**Project/File: Benari Estates/ EPP21-0021/ PPUD-07-21, RZ-12-21**

This is a preliminary plat, planned unit development, and rezone application to rezone a parcel from A to R-4 to allow for the development 133 single-family residential lots and 15 common lots on 35.29 acres.

Lead Agency: City of Eagle

SITE PLAN

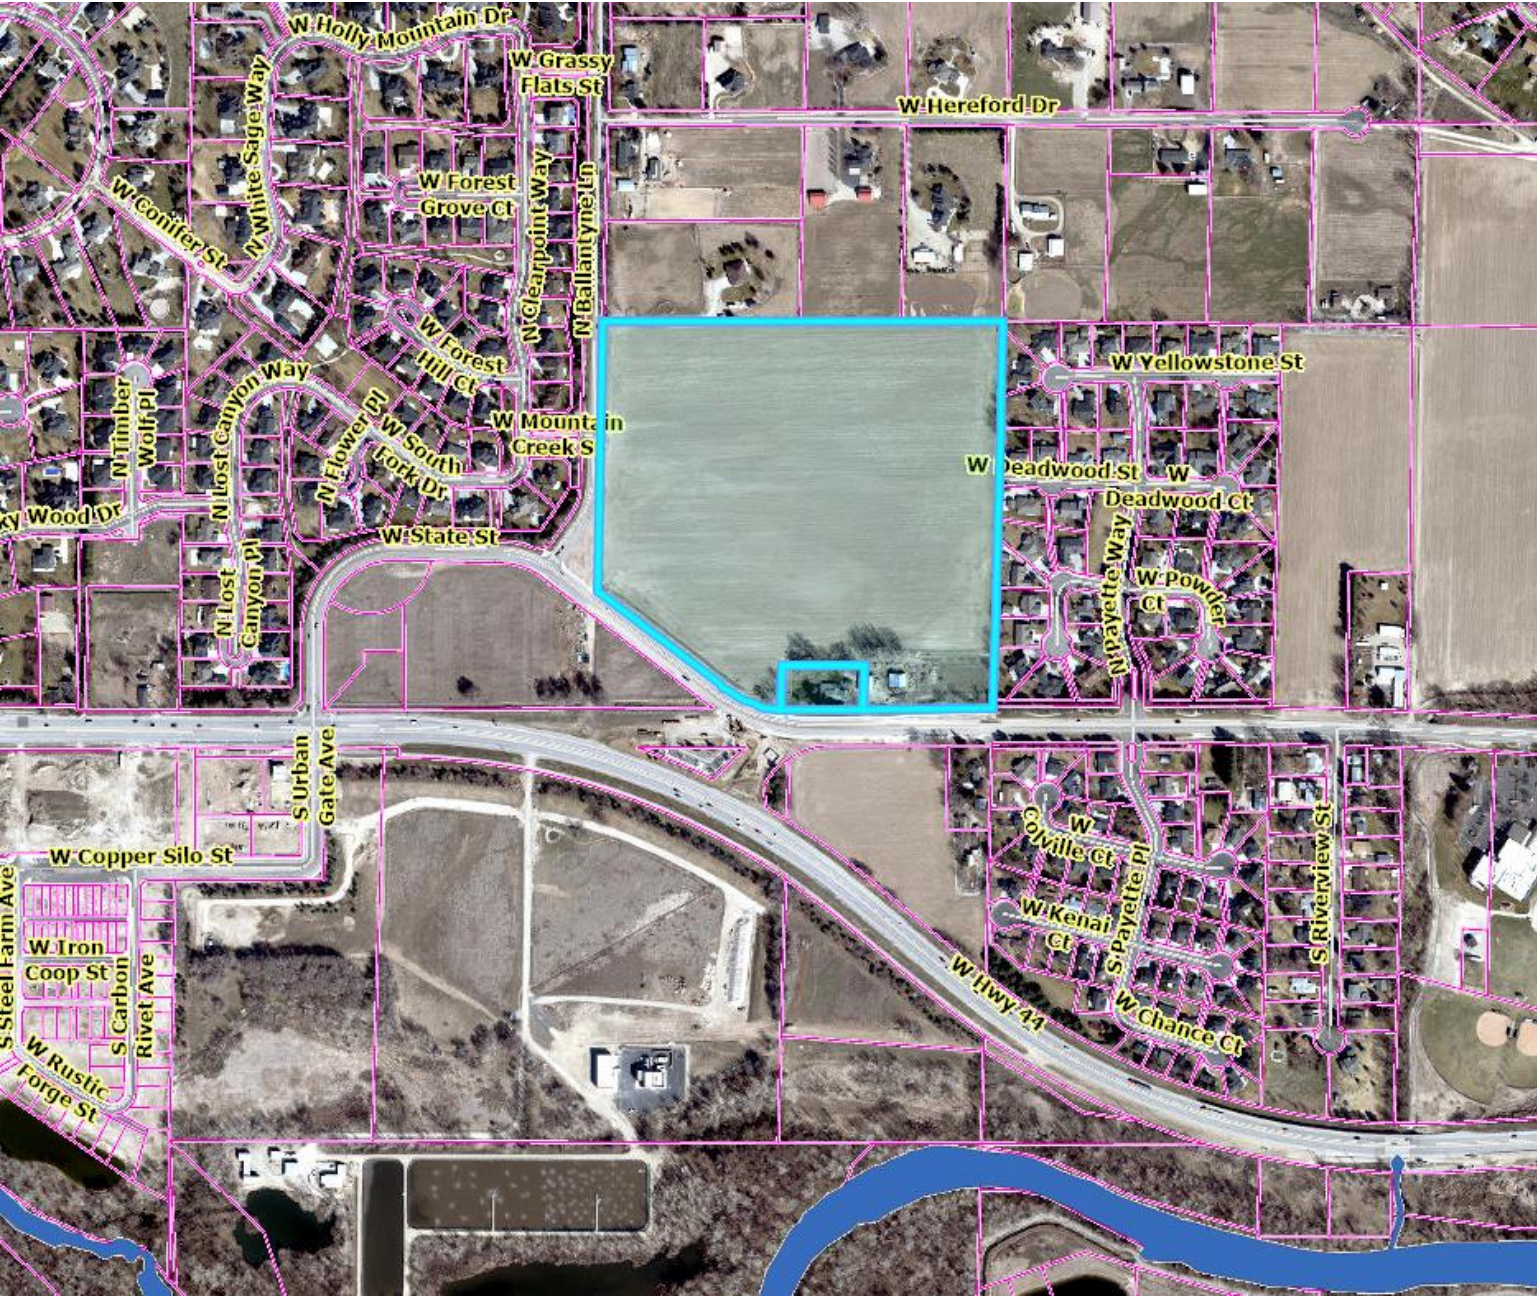
- d. **Staff Comments/Recommendations:** The applicant's proposal to improve Ballantyne Lane as a ½ a 35-foot rural collector street section does not meet District policy and should not be approved, as proposed. The applicant should be required to construct Ballantyne Lane as half of a 36-foot wide collector roadway with vertical curb, gutter, and 7-foot wide attached or 5-foot wide detached concrete sidewalk abutting the site. The applicant should dedicate additional right-of-way to extend 2-feet behind the back of curb for detached sidewalks and 2-feet behind the back of sidewalk for attached sidewalks. A permanent right-of-way easement should be provided for detached sidewalks located outside of the dedicated right-of-way.

A minimum 29-foot street section should be constructed around the center island proposed within the cul-de-sac at the terminus of Yellowstone Court. Parking within the island is prohibited.

Consistent with the recommendations of the traffic impact study, the application should be required to construct a bulb-out with a minimum of 24-feet measured face to curb to face of curb at the Yellowstone Street/Arrow Rock intersection.

- d. **Staff Comments/Recommendations:** If the City of Eagle approves the private roads, the applicant shall be required to pave the private roadway its full width and at least 30-feet into the site beyond the edge of pavement of all public streets and install pavement tapers with 15-foot curb radii abutting the existing roadway edge. If private roads are not approved by the City of Eagle, the applicant will be required to revise and resubmit the preliminary plat to provide public standard local streets in these locations.

The gated entry points on Powder Lane and Great Falls Lane should be located a minimum of 50-feet from the near edge of Forest Hill Drive and Deadwood Street and a turnaround should be provided.

3. Construct Ballantyne Lane as ½ a 36-foot collector street section with curb, gutter, and 8-foot wide planter strip and 5-foot wide detached concrete sidewalk. Dedicate additional right-of-way to extend 2-feet behind the back of curb and provide a permanent right-of-way easement for detached sidewalk located outside of the dedicated right-of-way.

4. Construct a center turn lane on Ballantyne Lane at Forest Hill (Mountain Creek) when Forest Hill is constructed to intersect Ballantyne Lane.
5. Close the existing driveway from the site onto Ballantyne Lane with curb, gutter, an 8-foot wide planter strip, and 5-foot wide detached concrete sidewalk, as proposed.

8. Construct a cul-de-sac turnaround with a center landscape island at the terminus of with an island Yellow Court, as proposed. Provide a minimum 29-foot street section around the center island and a minimum radius of 50-feet. Parking within the island is prohibited.
